Environmental Review Team Report

# Blackwell Terrace

Brooklyn, Connecticut

Environmental Review Team  
Report  
on

# FINAL SUBDIVISION PLAN

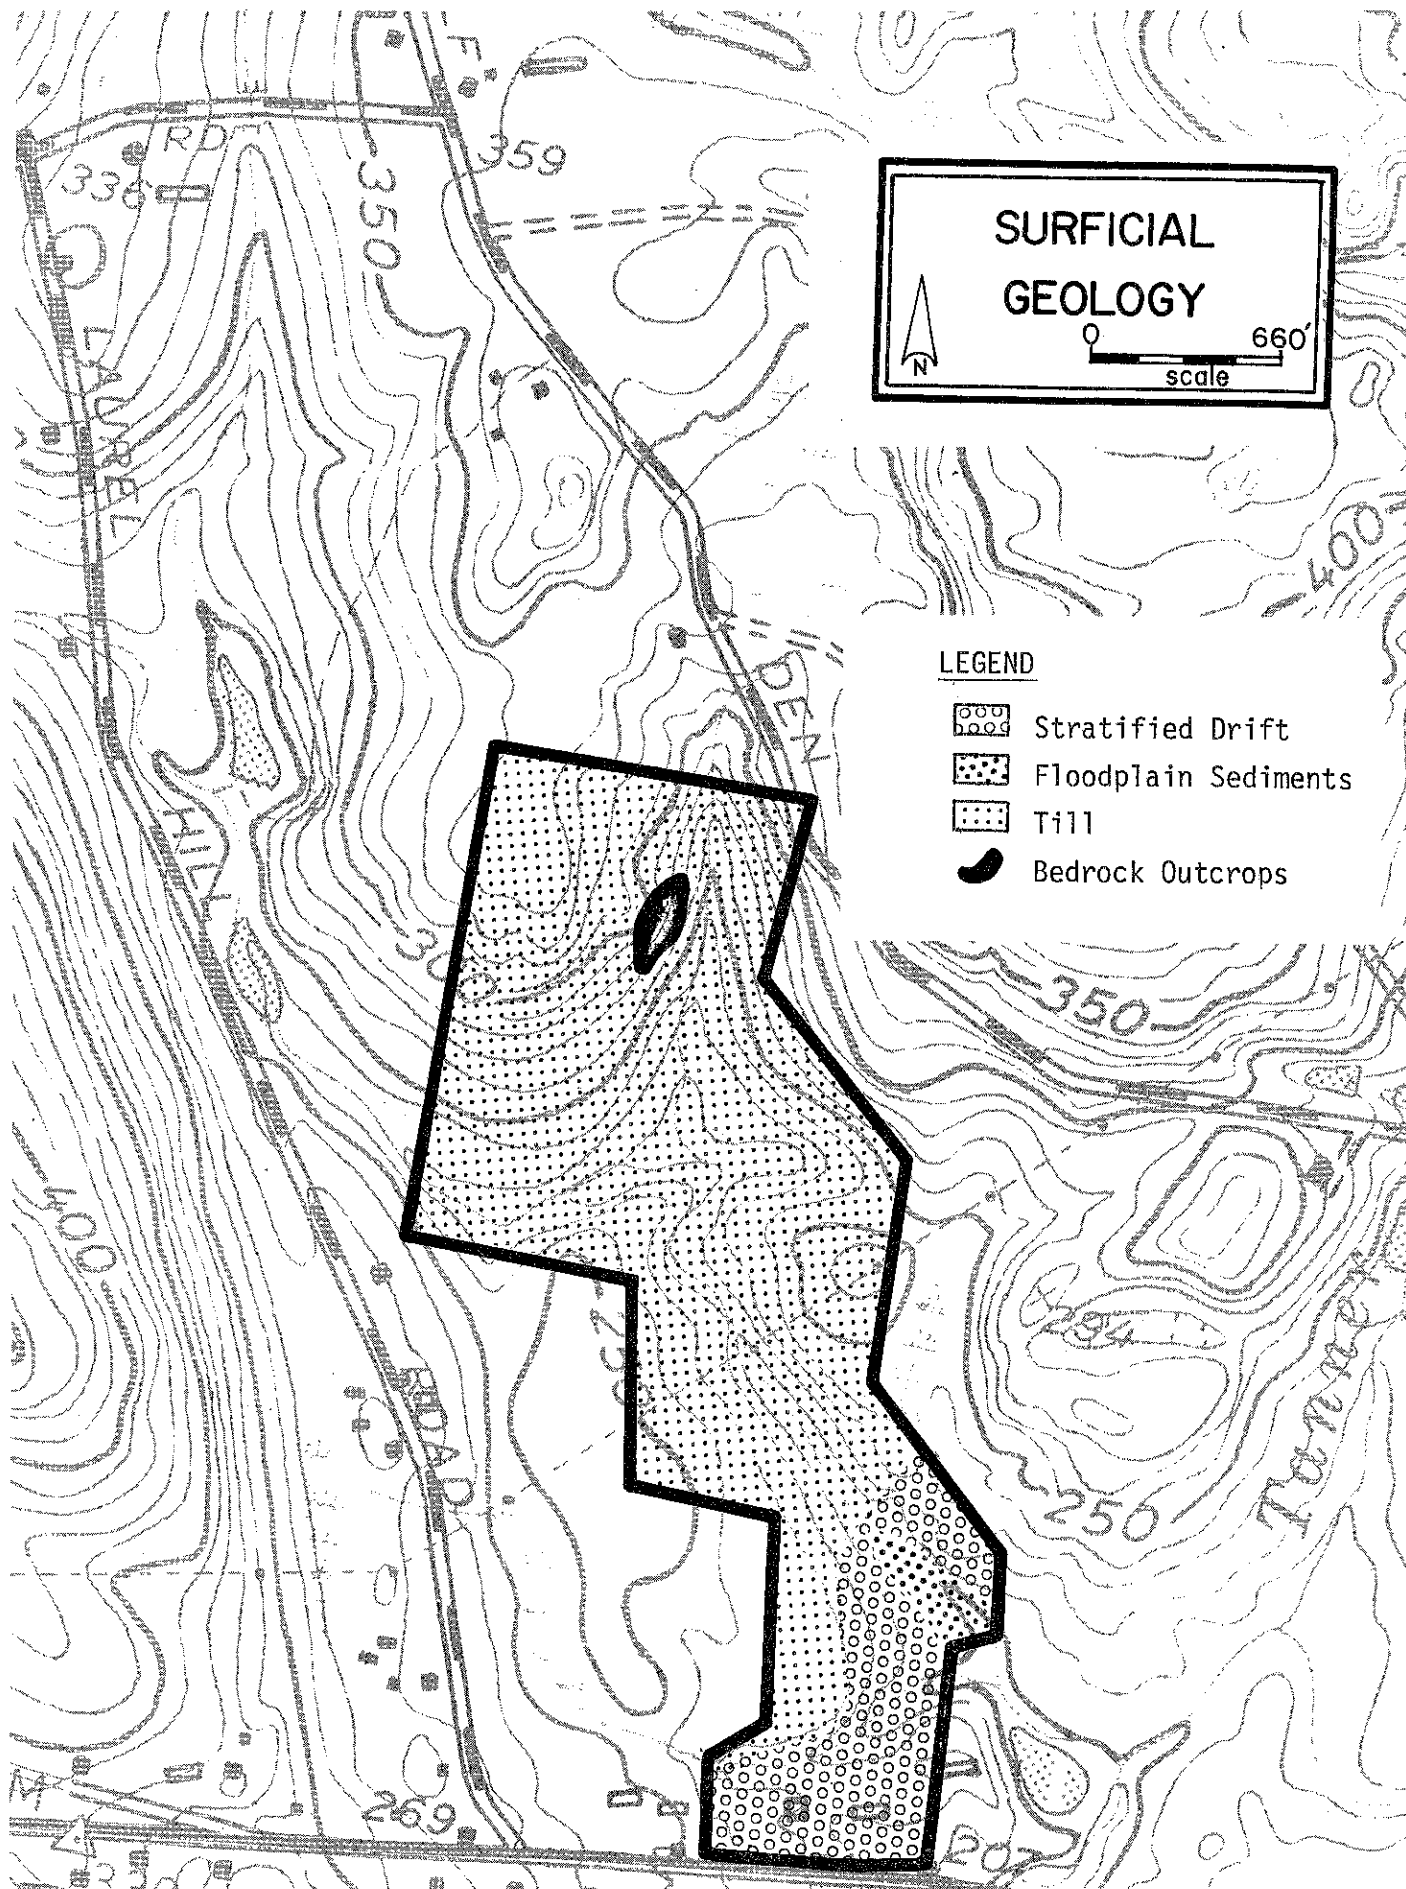
The Team is concerned with the difficulty in developing this tract of land due to the steep slopes and wetland soils on this site. This problem is compounded since wells and on-site septic systems must be used in this development. The present subdivision plan does not appear to take the existing soil limitations into account, as many of the lots are unsuitable for septic systems. Given the problems of developing this land, the proposed plan is not a very desirable solution. Lots 6, 7, 8, and 9 are particularly troublesome, and lots 10, 11, and 15 may also pose problems if the houses and support systems are not carefully designed.

Proposed lots 6, 11, 12, 13, 14, and 15 are unsuitable at this time for sewage disposal due to high groundwater conditions. At the time of inspection, lots 6, 11, 12, and 13 were at field capacity (saturated to the surface) with groundwater breaking out at the surface in several areas. The altitude and direction of groundwater flow appears to be in a westerly direction. In the area of the proposed road, groundwater was seeping to the surface and flowing down the slope onto proposed lots 8, 9, and 10. Since the water table slopes toward lots 8, 9, and 10, waste disposal systems located on lots 11, 12, and 13 could pose a threat to wells on these lots due to the proximity of the groundwater discharge area. Since sewage disposal systems will not adequately treat or dispose of liquid waste when

Large portions of lots 7, 8, 9 and 10 contain flood plain and are unsuitable for sewage disposal in those areas. The easterly portions of lots 8, 9, and 10 are severely sloped (with high groundwater and seepage from the slope evident) and are unsuitable for sewage disposal in those areas. Lot 7 is somewhat less sloped, but unsuitable for sewage disposal at this time.

The developer is proposing to construct a road through a wetland area for access to interior lots. Construction of this proposed road would require deep cuts and considerable fill and will be a source of a large amount of sediment eventually being washed into Blackwell Brook. Therefore, if work progresses as proposed, extreme care should be taken to contain sediment. It is strongly recommended that work be done during a period of low flow (usually August and September). This access road is shown as having a paved width of 28 feet and a subbase of 12 inches, which complies with subdivision regulations for a local road.

In an effort to make lots 7-10 more suitable for building, perhaps the proposed road could be moved some feet to the west. Lots 12, 13 and 14 could then be combined into two longer (N-S) lots resulting in more buildable land in lots 7-10.

Another possibility may be relocation of the road to the western property line on an existing, though unimproved, roadbed. Lots with fewer engineering and zoning encumbrances could then be made by redividing the parcel north of the wetland crossing, into longer (E-W) sections. In terms of protecting Blackwell Brook, this may be one of the better alternatives.

Also, it is assumed that supporting engineering calculations could be presented to substantiate the adequacy of the twin 30 inch culverts which are proposed under this roadway. This data would be very helpful if presented with the final subdivision proposal.

There are some lots on which it may not be possible to meet minimum front yard (50 feet) and side yard (40 feet) requirements without placing the house on wetlands or on steep slopes. To meet minimum setback requirements on lots 7, 8, and 9 a house would probably have to be placed on land with slopes of 15% or greater. The placement of a house within setback limits on lot 6 appears to be physically impossible without having part of the foundation in the wetlands.

Sufficient data on topography and wetlands were not available (on subdivision map) for lots 10 and 11, to judge the suitability of those lots for development. However, it would appear that in order to comply with setback requirements, a house placed on lot 10 would have to be placed either on steeply sloping land or wetlands, but this is indeterminate. Lot 11 is an "interior lot" with 50 feet of frontage on the cul-de-sac. Slope at the site of the test pits appears to be about 10% but two foot contour lines were not shown so this is just an estimate.

# FOREST STAND MAP

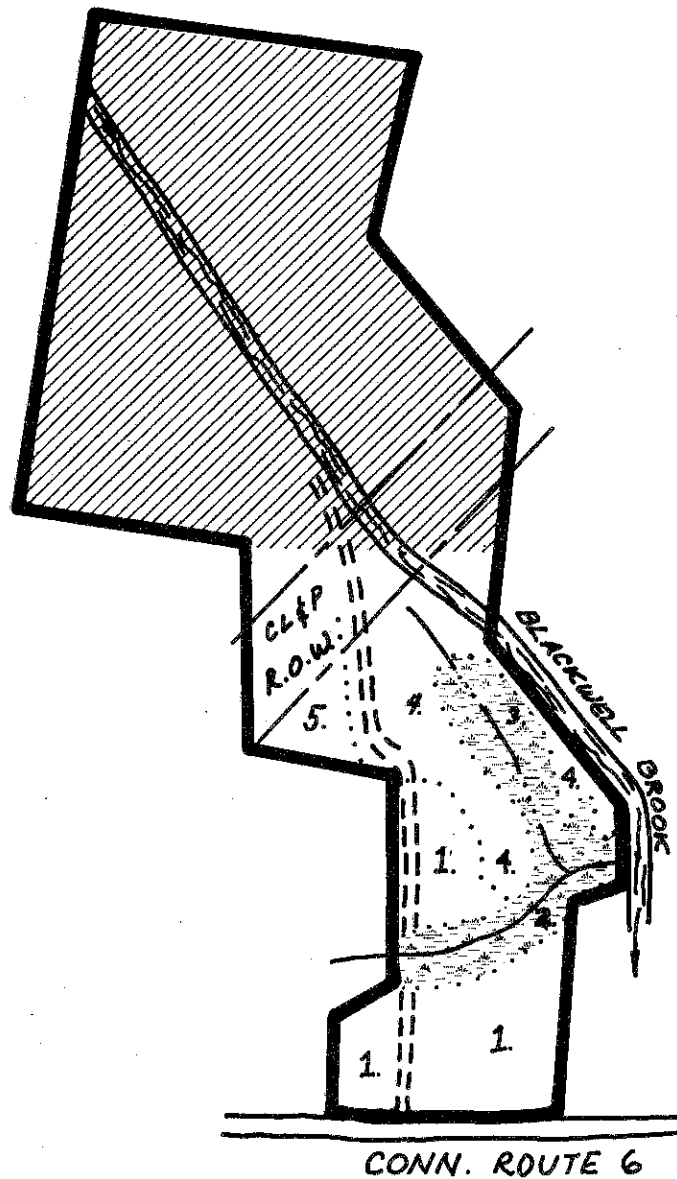
STAND TWO: This area is a one acre open wetland. The area immediately surrounding the watercourse is vegetated by hardwood saplings and wetland shrubs. As this area has great wildlife value, it should be disturbed as little as possible during development of this parcel. Perhaps rerouting of the main access road to utilize the existing laneway at the western boundary of the stand should be considered.
